Delegated Report

Application No:	20220745
Location:	377 Singlewell Road, Gravesend DA11 7RL
Description:	Erection of 2no five bedroom houses with outbuildings along with associated parking.
Applicant:	Mr Peter Chopra
Site Visit Date:	Various

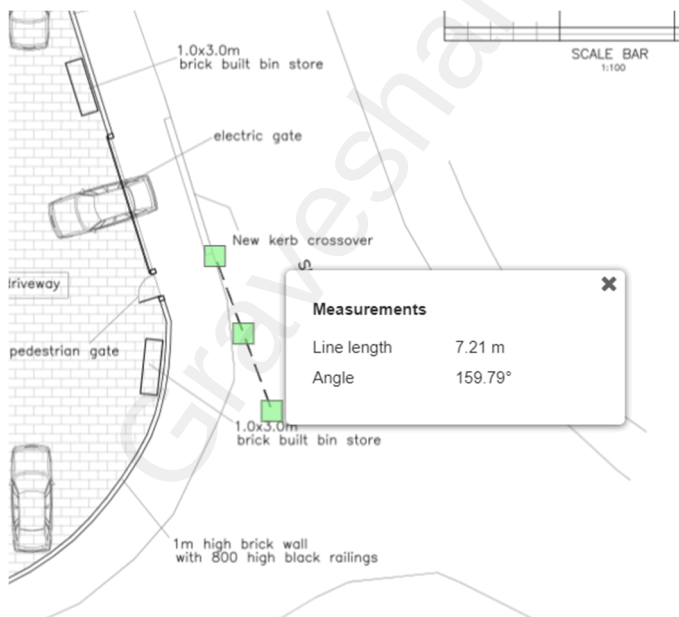
This proposal, due to the location of the new carriage crossover, gets an automatic recommendation of refusal. Guidance issued by Kent County Council states that;

If the location of the proposed crossing is closer than 10m to a road junction it would create a serious hazard and the application will be refused. This dimension may be increased to 15m on major roads or near to busy junctions. If the property is situated directly on the junction of two roads, it will generally be safer to situate the access on the minor, side road. Accordingly you may be asked to amend your proposals to comply with this requirement.

Therefore the County Council would not agree to providing a carriage crossover in the position

suggested meaning the access to the car parking area cannot be provided.

X distance

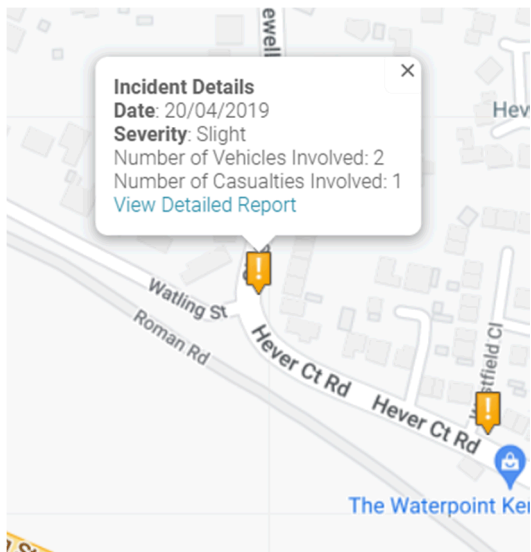
Given the location of the access (near a bend) and the fact that Singlewell Road serves as part of a direct link between the A2 and Gravesend it is not considered that part of a vehicle overhanging the carriageway is appropriate as an approaching vehicle may swerve to avoid with the risk of collision with an approaching vehicle. Looking at crashmap.co.uk there has been one accident in 2019. (details not checked) in the 5 years between 2017 and 2021 inclusive.

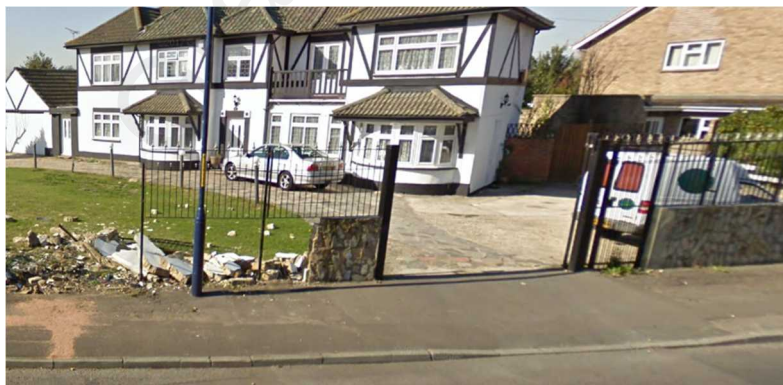
In terms of the proposed gates, looking at the various Google Street View images the existing gates never appear to have been used.

Footway visibility

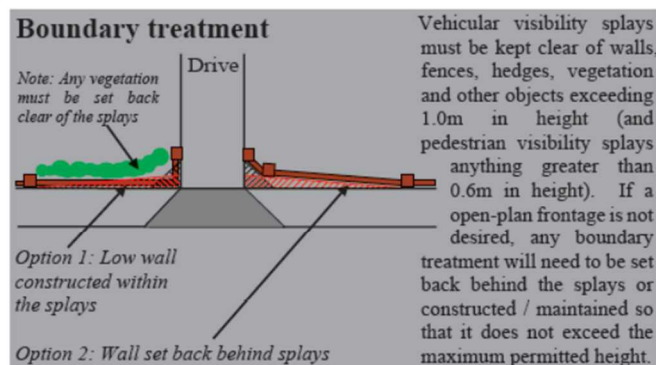
It is accepted that this guidance can be confusing, but pedestrian visibility splays should be clear of any hard or soft landscaping and boundary treatments exceeding 850mm in height, (reduced to 600mm where small children can be anticipated)

- (1) Proximity of access to junction to the detriment of road safety
- (2) Use of gates, which can leave a vehicle waiting on the highway whilst they are opened to the detriment of road safety and free flow of traffic
- (3) Suitable pedestrian visibility splays are not provided, (boundary treatment should not exceed 850mm) to the detriment of highway safety.

The previous application (20220360) was for the following:

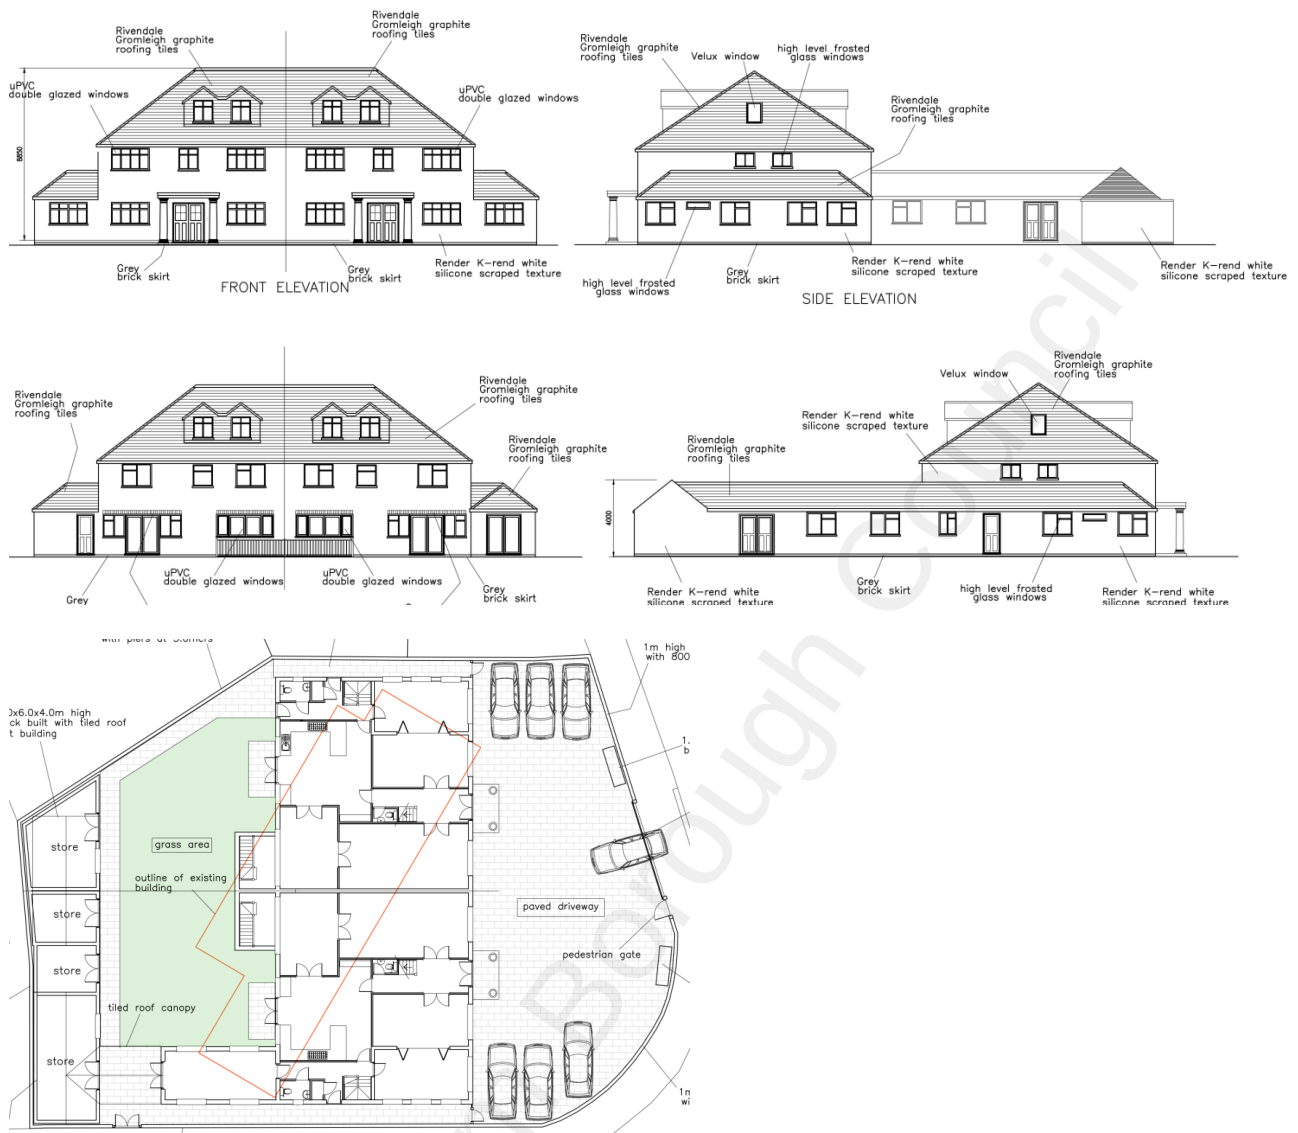
1. The proposed development, due to the appearance and awkward arrangement of the front dormer windows in relation to the fenestration below, loss of biodiversity and lack of soft landscaping to the front and amount of built form at a height of approx. 4m to the south-western boundary results in a bulky and cramped form of development on a prominent site to the detriment of the character and appearance of the area contrary to policies CS12 and CS19 of the Gravesham Local Plan Core Strategy 2014 and para. 130 of the National Planning Policy Framework 2021.

2. The area of the rear garden of the southernmost property falls short of the required 100sqm for a four bedroom house and, due to the number of bedrooms, basement and numerous outbuildings, the insufficient garden space will have a detrimental impact on the enjoyment of the property for future occupiers and therefore conflicts with the Gravesham Residential layout guidelines 2020, policy CS19 of the Gravesham Local Plan Core Strategy 2014 and para. 130f of the National Planning Policy Framework 2021.
